**Re: OPA/ZBA Application Resubmission #2 (OZ/OPA 25-23 W8)
1970-1980 Fowler Drive, Mississauga (Ward 8)**

RE: 1970-1980 Fowler Dr OZ/OPA 25-23 W8 - Comment Response

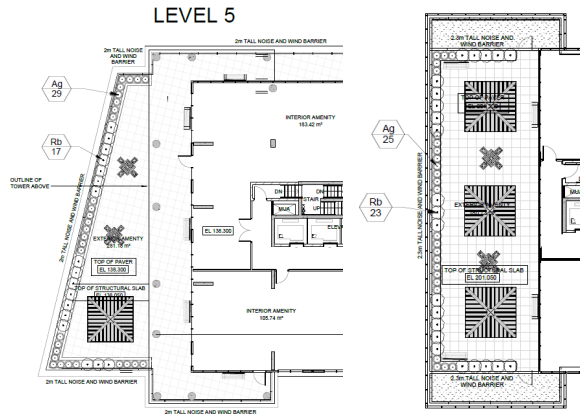
Thanks for providing the excerpts below. The notes at the upper levels should match the ones provided at grade. Please revise them to also indicate "Final length and configuration to be confirmed during the SPA".

The barriers and heights are noted on the upper level amenity areas. Please confirm if these are satisfactory or if further detail is required.
2m on Level 5, and 2.3 m on the rooftop.

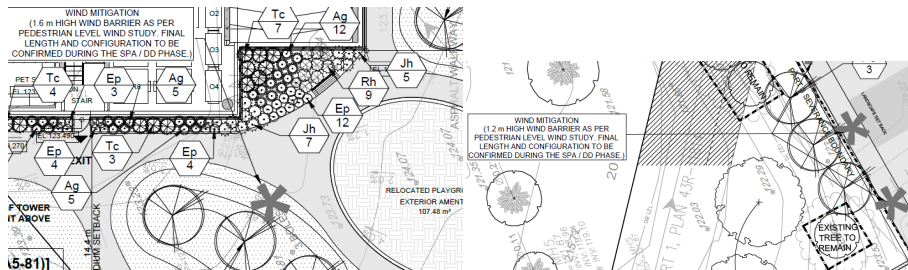
Please revise and provide confirmation of those notes as well. Once those are complete the comment would be addressed for processing of the OZ application. The detailed Quantitative Wind Study would then be required for review during processing of the Site Plan Application.

[@Dave Craig](#) We have noted the general height and location of the wind mitigation structures in alignment with the submitted Wind Study. The Wind Study does not note recommended lengths, which your comment requests.

As our drawings are now in agreement with the Wind Study, is this revision sufficient? Please let us know. See notes below. We're planning to submit this week, so your confirmation will be appreciated.

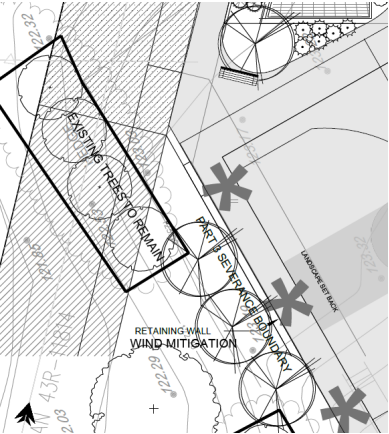
75	REGION OF PEEL Rosha Budathoki 2-19-26 1:36 PM	Comment EASEMENT - There is a Regional easement (VS17870 / PR2466944) on the subject property. Please note that all drawings must clearly show the existing easements, their limits, the purpose of the easement, the easement instrument number, parts and reference plan number, and the benefiting party (i.e. the Region). Unauthorized encroachments on Regional easements will not be permitted. Certain restrictions apply with respect to Regional easements as per the documents registered on title. Existing easements dedicated to the Region of Peel for the purpose of sanitary sewer and/or watermain, must be maintained or the existing infrastructure relocated to the satisfaction to the Region of Peel, at the owners cost. Foundations of proposed structures must not encroach on the zone of influence of the existing structure. The applicant shall notify the Region of any proposed encroachments on the easement, including structures, signs, landscaping, walkways, parking and servicing. The Region notes that there is a landscape buffer proposed over the easement with deciduous trees shown in the northern corner (next to the basketball court). Please confirm that these trees are existing and if any other landscaping materials are proposed within the boundaries of the easement. Please note an encroachment review and an encroachment agreement, including associated fees, may be required should any encroachments be proposed within the Region's easement.

To clarify, the trees within the N corner of the site (within the easement) are **existing**. Attached please find our latest draft LA plan that identifies this clearly. **Please let us know if you have any questions, concerns or further action required on this matter.**

Thank you for the clarification. If the trees are pre-existing, then it's fine. I will file this email and formally clear the comment when the application is recirculated on ePlans. Please ensure to keep us notified of any potential encroachments on the easement.
